STATE OF VERMONT  
PUBLIC UTILITIES COMMISSION

Investigation Pursuant to 30 V.S.A. §§ 30 and )  
309 regarding the alleged failure of Vermont )  
Gas Systems, Inc. to comply with the )  
Certificate of Public Good in Docket 7970 )  
 ) Case No. 17-3550-INV  
 )  
 )  
 )

**INTERVENORS’ SUMMARY OF THE EVIDENCE FOR INDEPENDENT  
INVESTIGATOR WILLIAM BYRD, PE (annotated with attachments)<sup>1</sup>**

Photograph 4: Station 1649+00; trenching and lowering in the pipe through Clay Plains. Topsoil and subsoil are segregated and placed on timber mats. Photograph taken looking north.

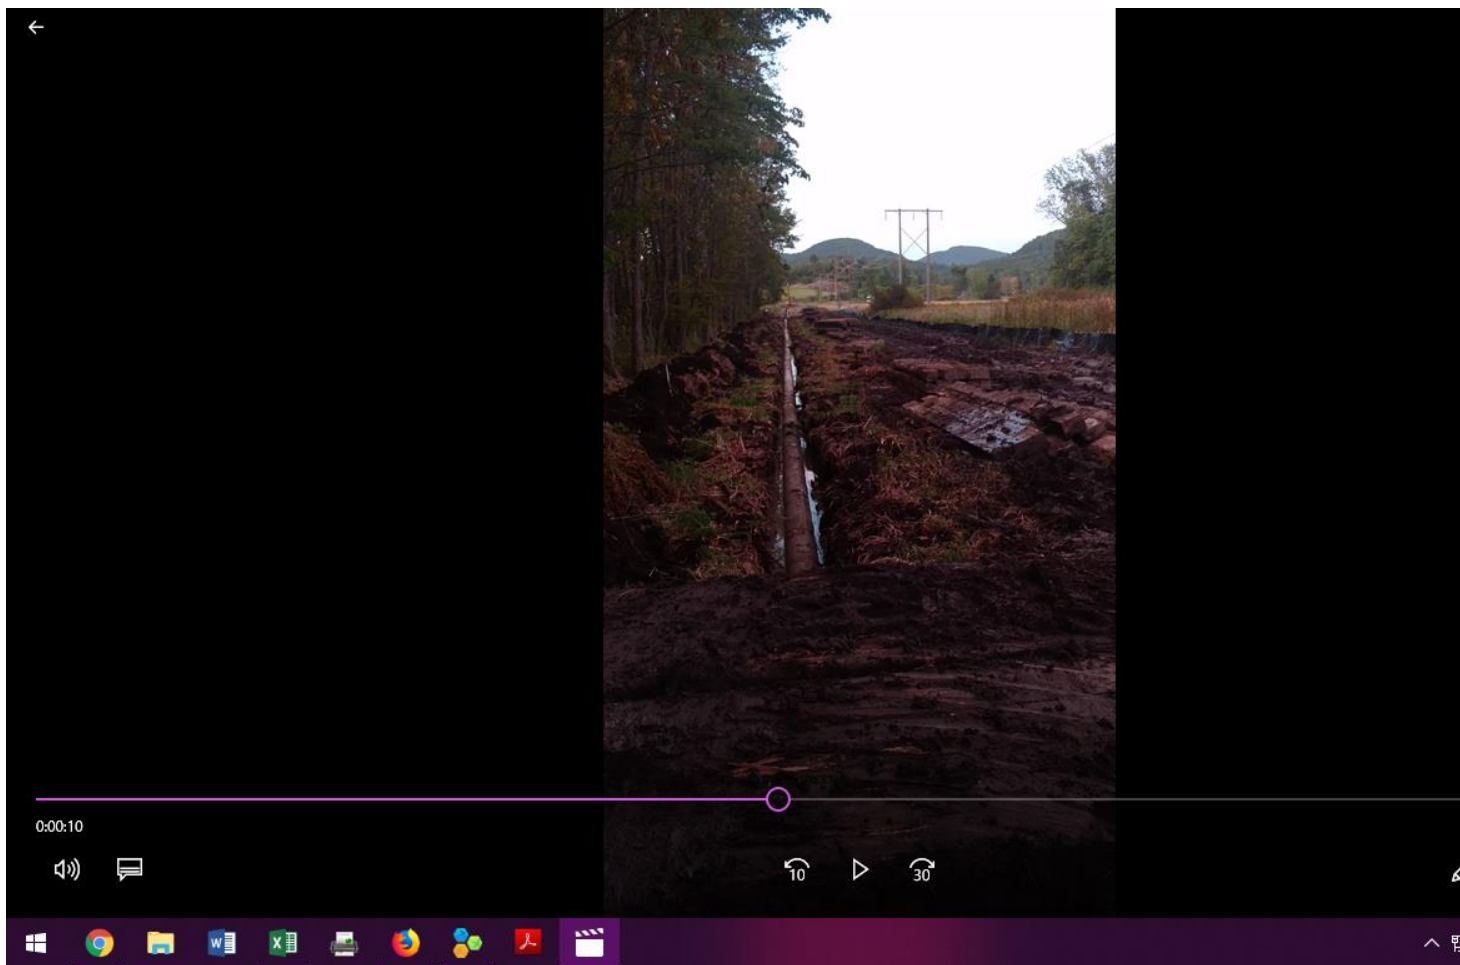
**Photograph #4 [SUPPLEMENTAL ATTACHMENT #2.]**, taken by VGS’s contractor, VHB, depicts the pipeline in Clay Plains Swamp in New Haven. It is dated September 15 and 16, 2016.

But that photo does not show what really happened. Before the pipe could be covered, the wetlands around it poured water into it. **Mr. Shelton’s photographs, video and affidavit** show the condition the pipe was in when it was buried. His photographs and video were taken in the exact same location as Photograph #4, as shown by the trees along the trench, the cattails across from the trees, and the double ridge of mountains in the background. [**See SUPPLEMENTAL ATTACHMENTS #3A, 3B, 4 AND 5, FROM MR. SHELTON.** **Mr. Bubolz’ deposition [APPENDIX PAGES 742-879]** describes what these photos show. The trench became flooded with water and

the walls collapsed. One excavator, even though it was on mats, slid into the wetland and could not get out. Other equipment had to be brought in to remove it. It became impossible to achieve 4 feet of burial within the VELCO ROW; they could not even attain 3 feet. As a result, according to Mr. Bubolz, a Michels foreman, VGS employed a third method, the “sink in swamp” method. It was, according to Mr. Bubolz, a method unlike the two methods in the written specifications (open trench construction and HDD). The new method consisted of digging trenches on either side of the pipeline and relying on the weight of the pipeline to squeeze soils out from beneath it. No sand or other select backfill was placed beneath the pipe. No excavation of a level area, and no inspection of that level area before placement of the pipeline on it, occurred. No inspection was conducted for rocks or soil clods over 3 inches long or 6 inches long in the backfill (other than the backhoe operators’ observations from the seats of their equipment). No compaction of backfilling occurred, and soon after construction the ground subsided over the pipeline resulting in a depression that filled with water, so that this portion of the pipeline is now underwater.<sup>2</sup> The company and its contractors made this method up as they went along. Nothing was in writing. This unwritten method was used for a 2500-foot long area New Haven witnessed by Mr. Bubolz. It also occurred further south, in another roughly 1300-foot long stretch, according to Mr. Bubolz. If the walls of the trench had been shored up by sheeting, all of this could have been avoided, but VGS refused to authorize use of sheeting. *Bubolz Deposition* pp. 28, 31-32, 42-43, 47-48, 62, 78, 102, 110-111, 113-114, 122, 133 [APPENDIX PP.742-879].
